MICAH JEUB
 GLAMPING II
 SITE DEVELOPMENT PLAN

File Number: PPR2433

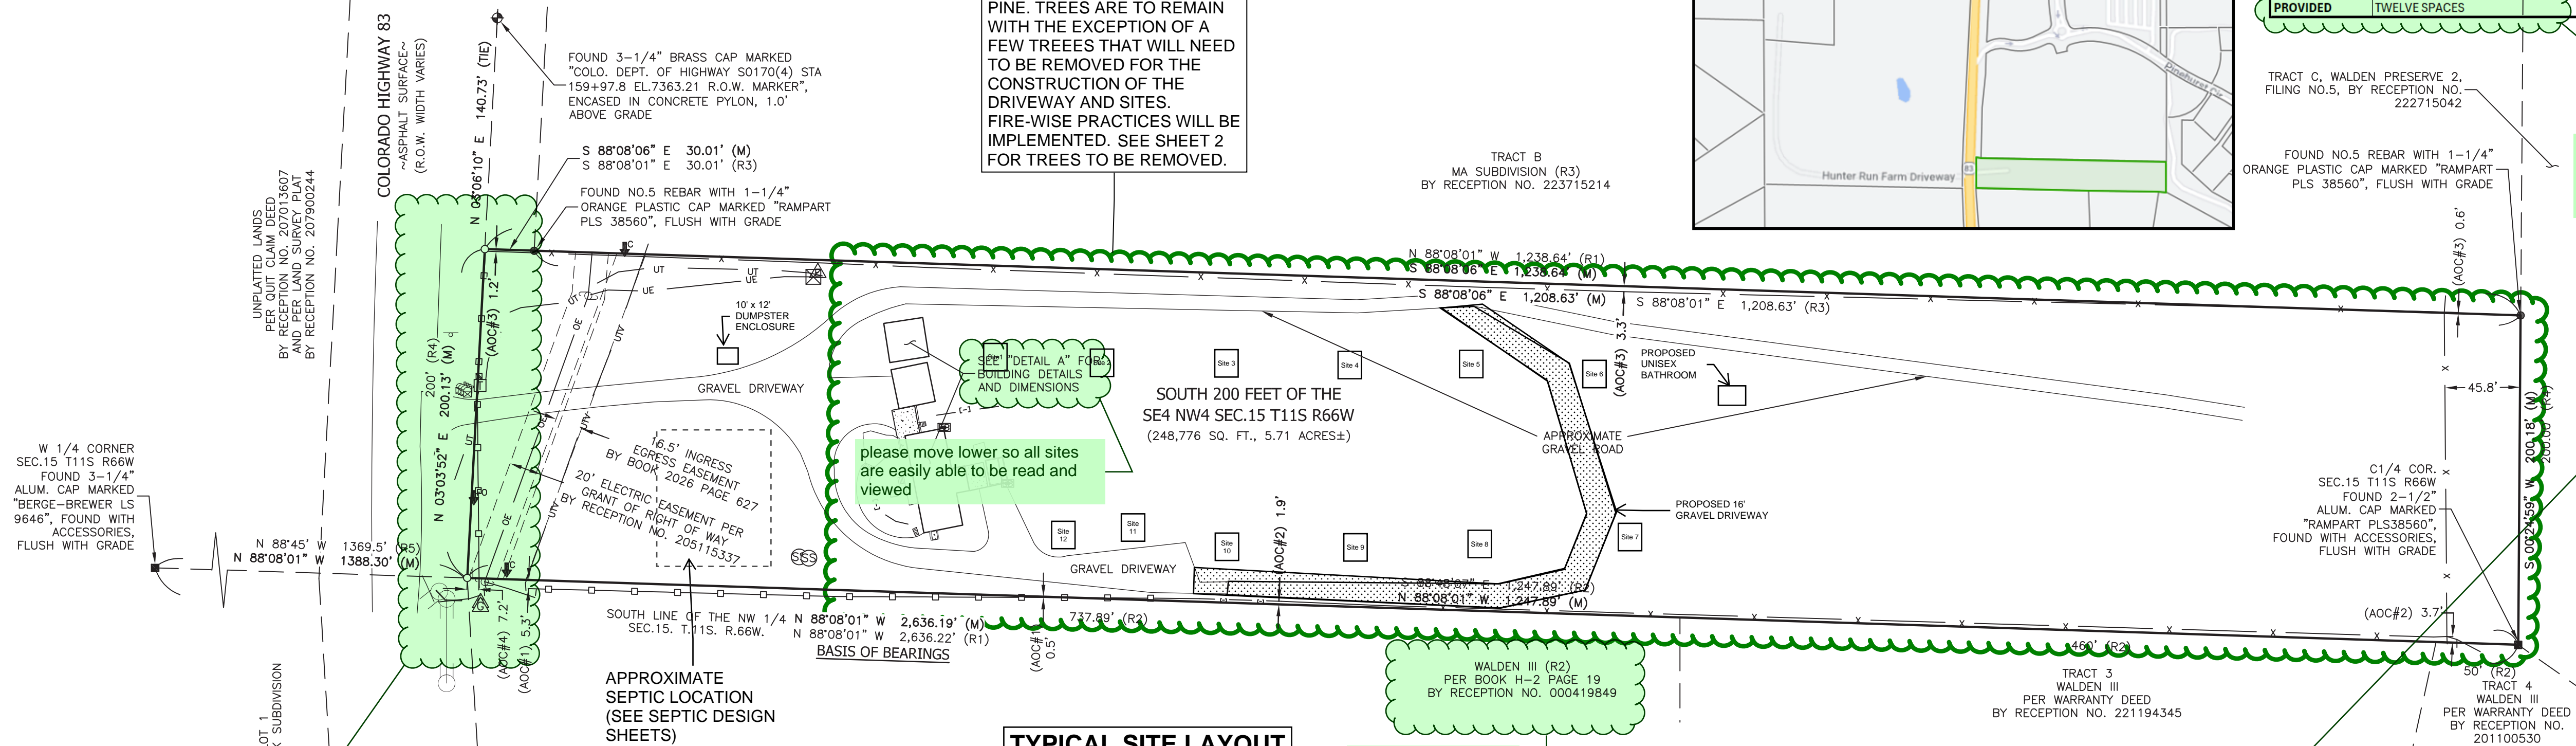
Please include:
 -Title document "Substitute Landscape Plan"
 -Indicate the percentage of coverage on site via trees/ "landscaping"
 Notes:
 -This is phase 1 of phase 2 of the Site Development Plans associated to Special Use approval AL2318 and each phase is for 12 sites only.

Please include sight distance triangles and any signs, plantings, or other visual obstructions if applicable

please move lower so all sites are easily able to be read and viewed

At a minimum 1 ADA space must be provided, please adjust accordingly

Please move to this location

Please include zoning of adjoining properties

Please remove
